UNITED STATES PATENT AND TRADEMARK OFFICE

APPLICATION NO.	FILING DATE	FIRST NAMED INVENTOR	ATTORNEY DOCKET NO.	CONFIRMATION NO.
10/576,714	04/17/2006	David M. Szmyd	US030472US	6310

Office Action Summary	Application No.	Applicant(s)	
	10/576,714	SZMYD, DAVID M.	
	Examiner	Art Unit	
	W. Wendy Kuo	2826

DETAILED ACTION

FIG. 6

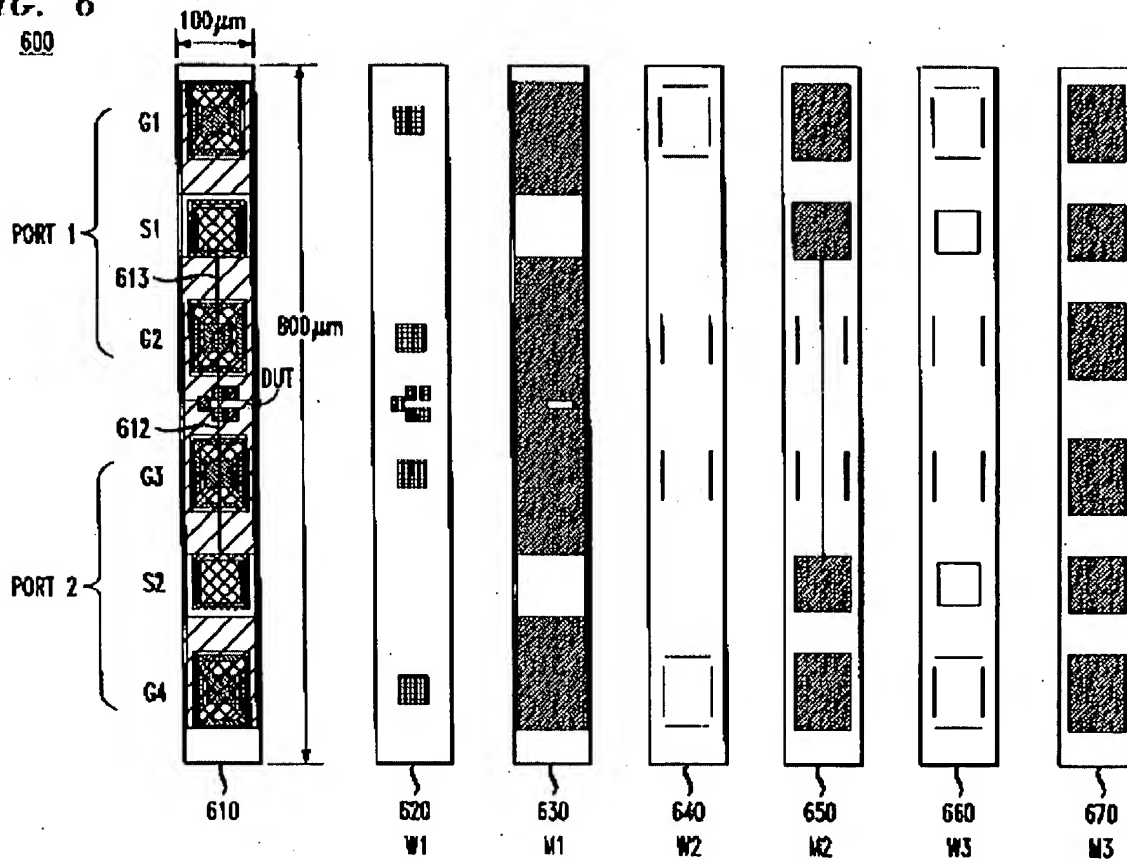
7. With respect to claim 1, Ivanov et al. teach in Figure 6 a ground-signal-ground (GSG) test structure for production measurement of RF device performance in integrated circuits, comprising one pair of signal pads (S1, S2) (**S1, S2**) and two pairs of ground pads (G1a, G2a; G1b, G2b) (**G1, G3; G2, G4**), wherein all said six pads (G1a, G2a, S1, S2, G1b, G2b) are arranged linearly.

10. With respect to claim 10, Ivanov et al. teach in Figure 6 an arrangement of GSG testing pads comprising one pair of signal pads (S1, S2) (**S1, S2**) and two pairs of ground pads (G1a, G1b; G2a, G2b) (**G1, G2; G3, G4**), wherein all of said pads (G1a, G2a, S1, S2, G1b, G2b) are arranged linearly.

15. With respect to claim 6, Ivanov et al. further teach in Figure 6 that the device under test (DUT) is placed between said pair of signal pads (S1, S2).
